CITY OF West Linn

STAFF REPORT FOR THE PLANNING COMMISSION

FILE NUMBER: DR-15-11/LLA-15-01

REQUEST: Class II Design Review and Property Line Adjustment to construct 180 multi-family dwelling units and 1,973 square feet of commercial space at the northwest corner of the intersection of Tannler Drive and Blankenship Road.

Image 3 **Adjusted Units of Land**

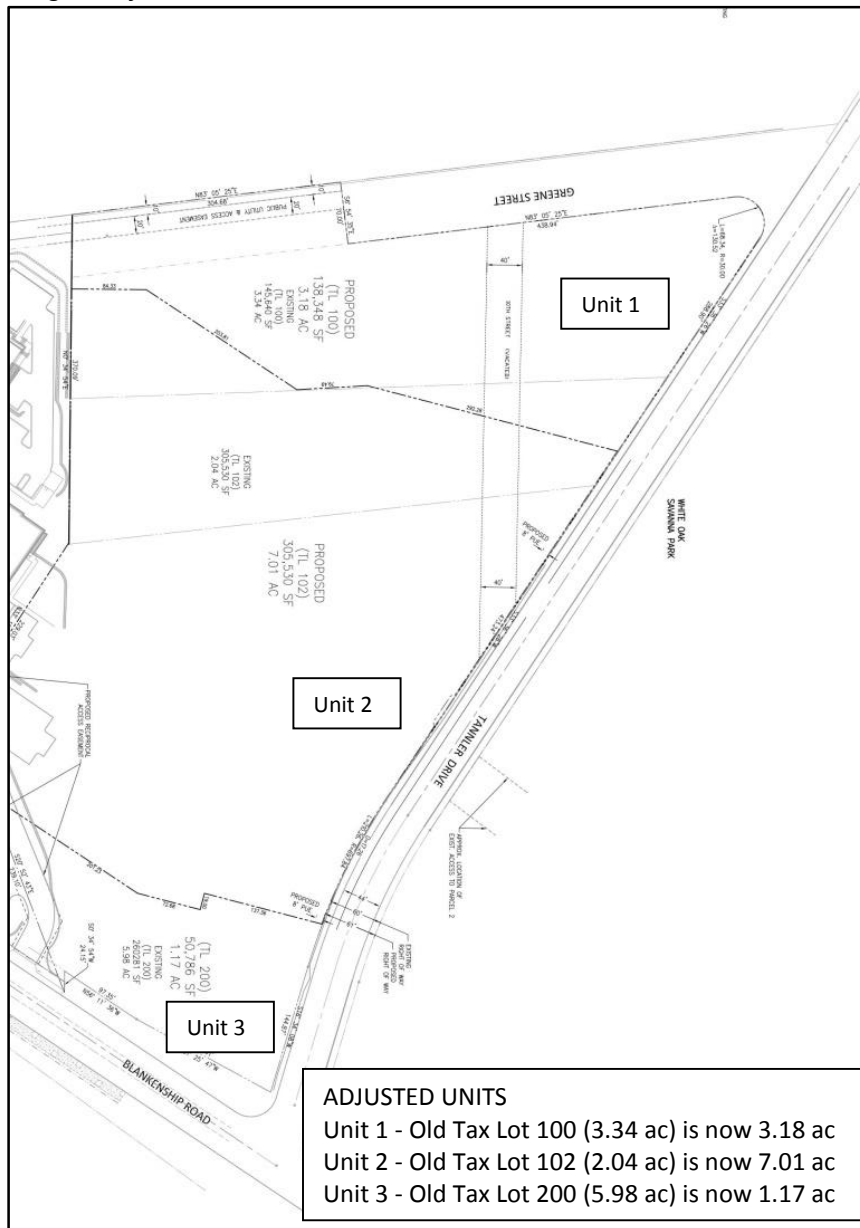
13. **Property Line Adjustment.** The final Property Line Adjustment Map shall be submitted to the City of West Linn for approval prior to recording. This map shall substantially conform to the property line adjustment as shown on Sheet P1.2
